## Change Order

Project:  
20-15092 WILCO ANNEX - GC  
151 WILCO WAY  
GEORGETOWN, TX

Change Order: 15

The Contract is changed as follows:  
Misc Subcontractor Change Orders

REF #: ADD BIPASS DR. JP203A

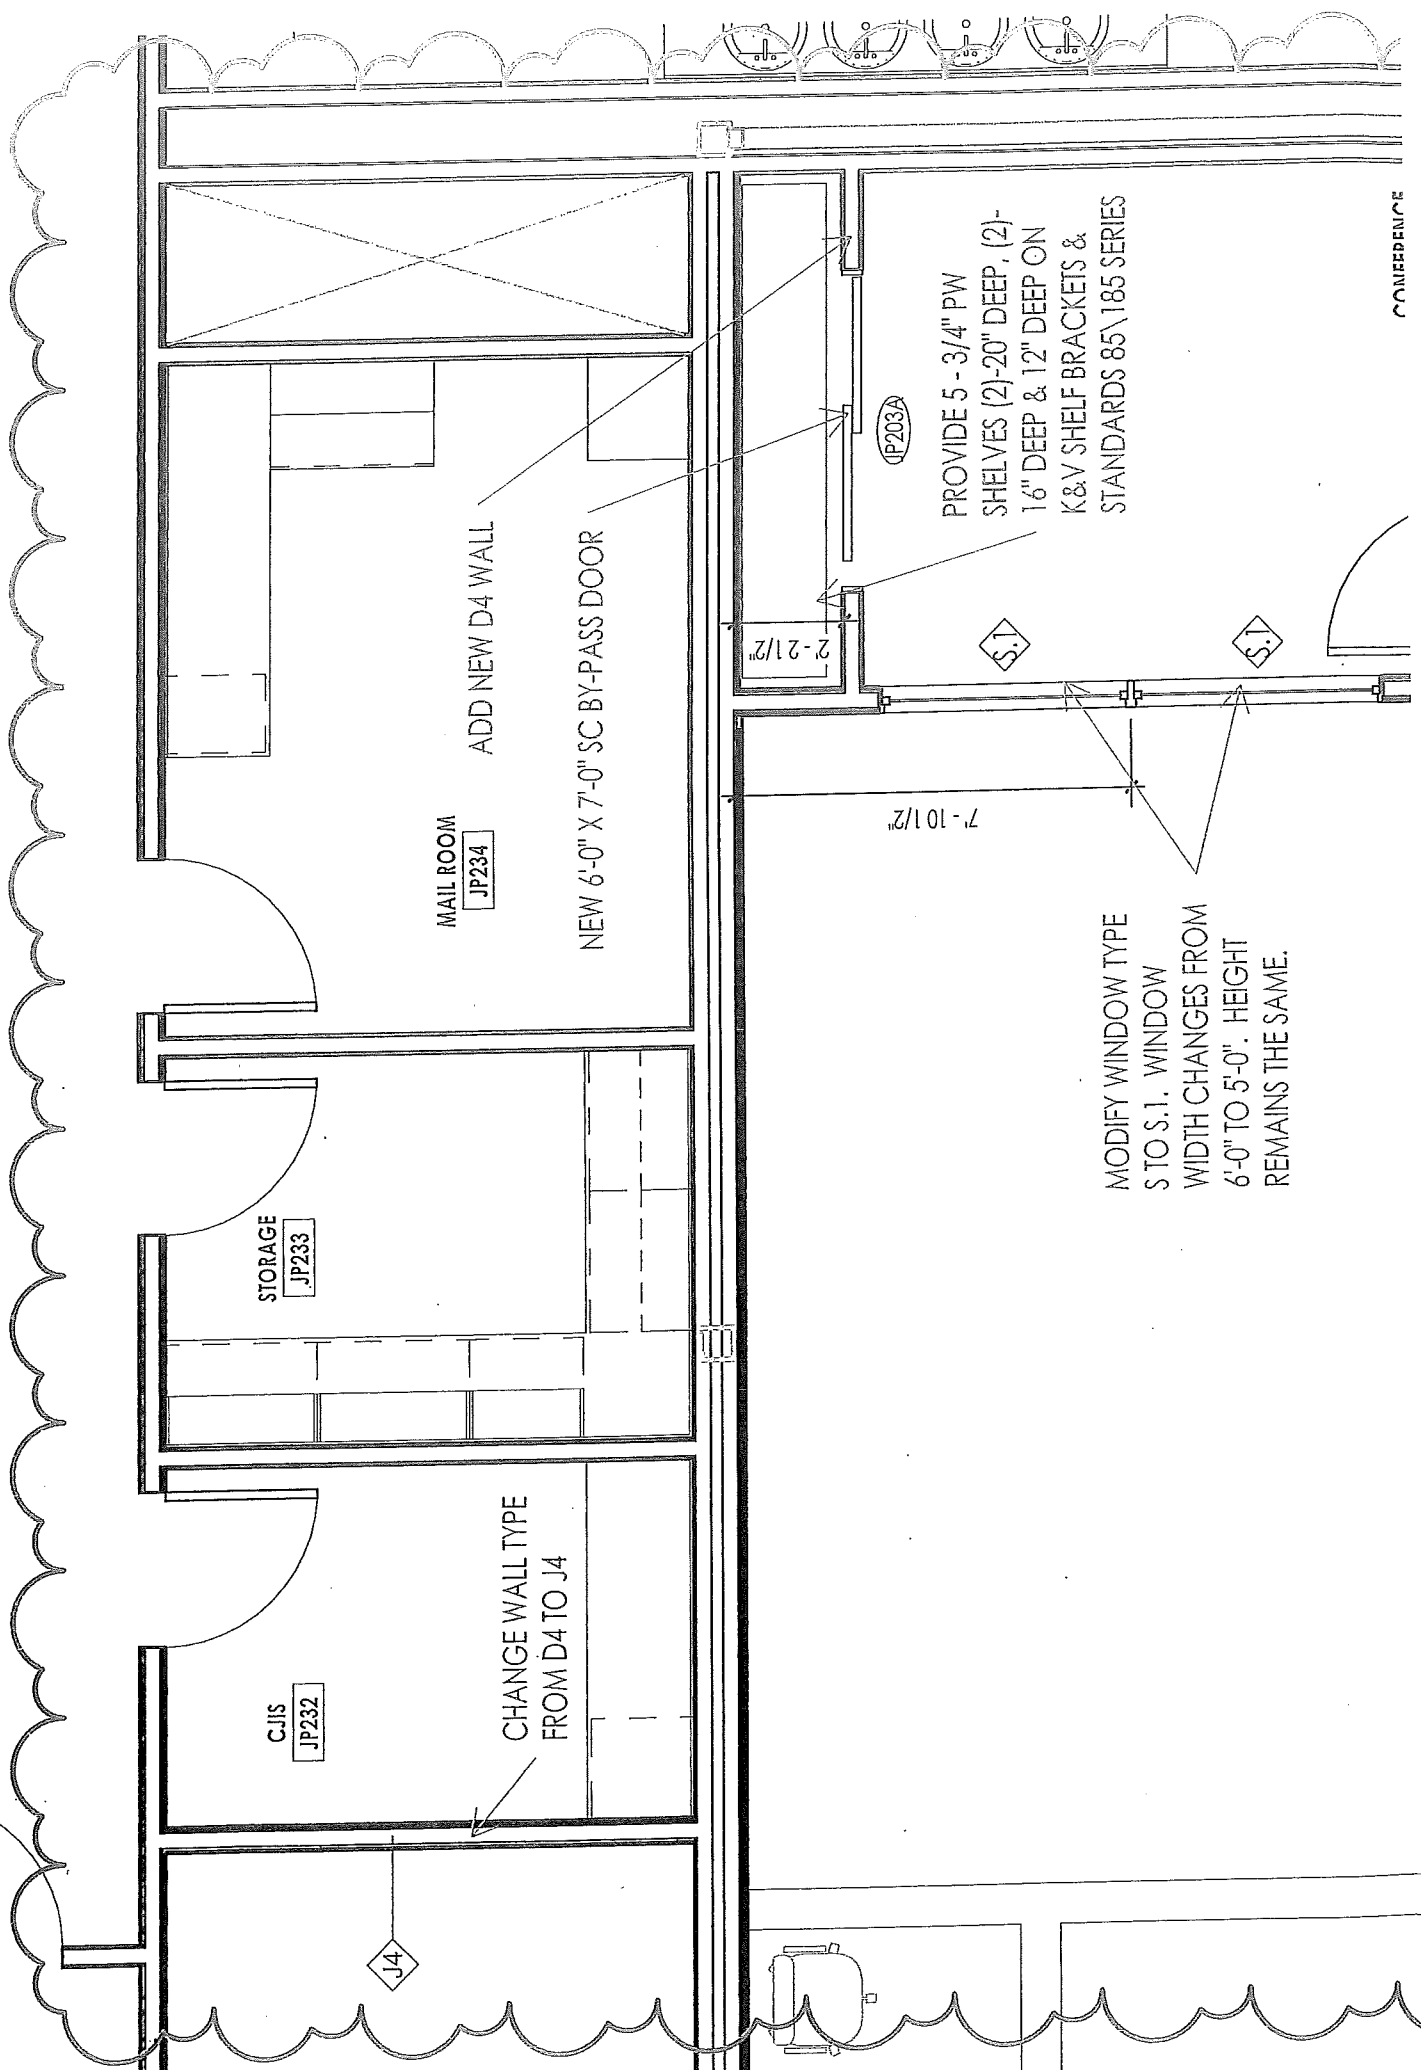
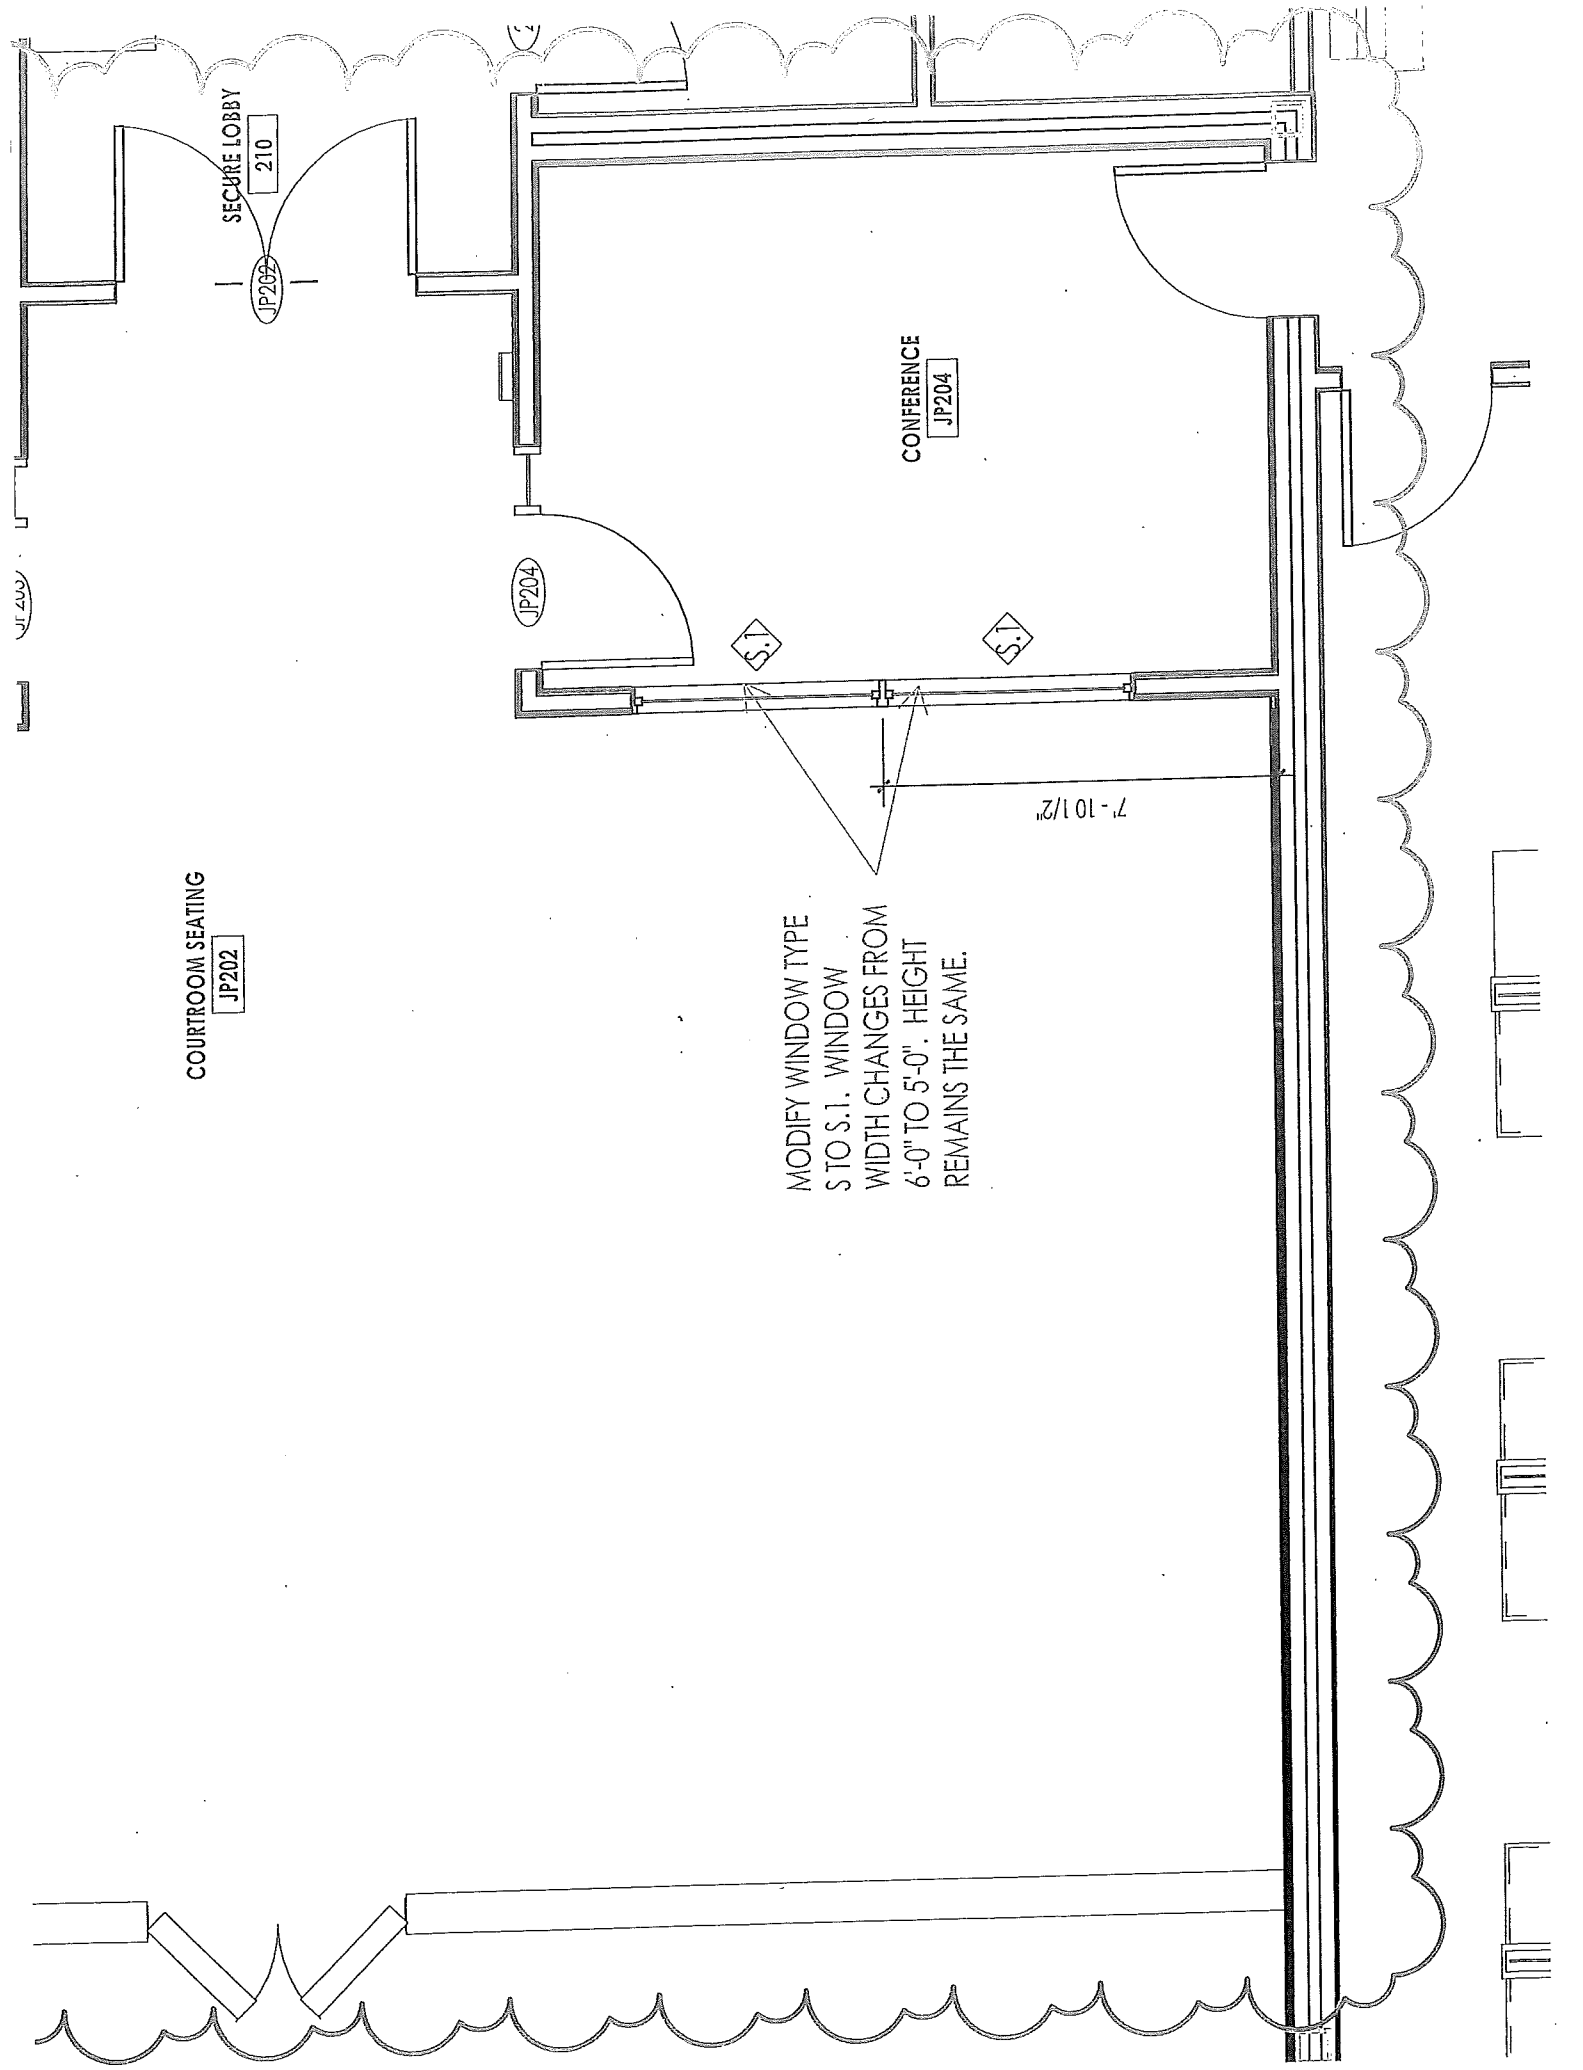
MODIFY WINDOW TYPE  
STO S.I. WINDOW  
WIDTH CHANGES FROM  
6'-0" TO 5'-0". HEIGHT  
REMAINS THE SAME.
